# Access Compliance Report

## Public Rights-of-Way

### (Curb Ramps)

Intersection ID: 25357	Main Street: RAINTREE_LN	Cross Street: WILLOW_POINT_DR	Location: NE
ADA ID: C3332FBC84D1	Ramp Type: Perp	Initial Pass/Fail: Fail	Overall Compliance: No
Codes/Mitigation Info/Possible Solution		Field Measurements/Component Compliance

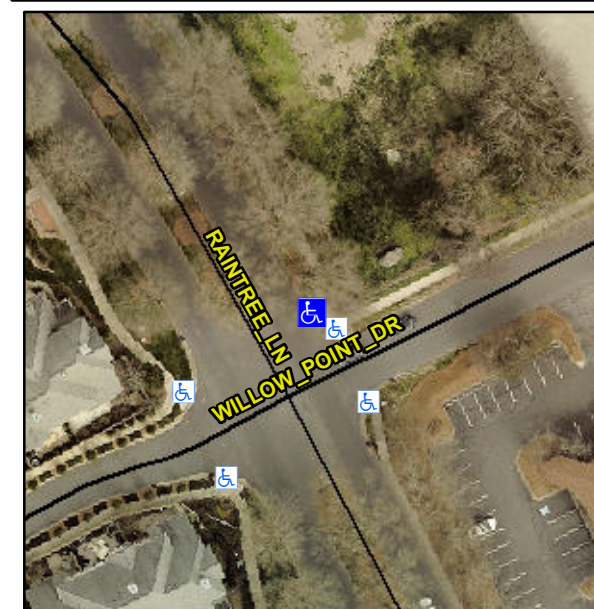
**Not Found, R304.2.2, R304.5.3**

Compliance	Description	Data	Compliance	Description	Data
N/A	Ramp Length (in)	54.0	No	Ramp Slope (%)	8.4
Yes	Ramp Width (in)	52.5	No	Ramp XSlope (%)	2.6
N/A	Flare Type LT	N/A	N/A	Flare Type RT	N/A
N/A	Flare Slope LT (%)	N/A	N/A	Flare Slope RT (%)	N/A
N/A	Flare Traversable LT?	N/A	N/A	Flare Traversable RT?	N/A
N/A	Landing Length (in)	N/A	N/A	DWS Provided?	N/A
N/A	Landing Width (in)	N/A	N/A	DWS Contrast?	N/A
N/A	Landing Slope (%)	N/A	N/A	DWS Length (in)	N/A
N/A	Landing X Slope (%)	N/A	N/A	DWS Full Width?	N/A
N/A	Landing Curb? (Y/N)	N/A	N/A	DWS Offset (in)	N/A
N/A	Shared Landing?	N/A			
N/A	Gutter Ponding?	N/A	N/A	Gutter Slope (%)	N/A
N/A	Gutter Lip Ht (in)	N/A	N/A	Gutter X Slope (%)	N/A
N/A	Painted X Walk1?	No	N/A	Painted X Walk2?	N/A
	X Walk 1 Direction	To SW		X Walk 2 Direction	N/A
N/A	X Walk 1 Width (in)	N/A	N/A	X Walk 2 Width (in)	N/A
	X Walk 1 Slope (%)	4.3		X Walk 2 Slope (%)	N/A
	X Walk 1 X Slope (%)	2.4		X Walk 2 X Slope (%)	N/A

**Remove & Replace Entire Ramp.**
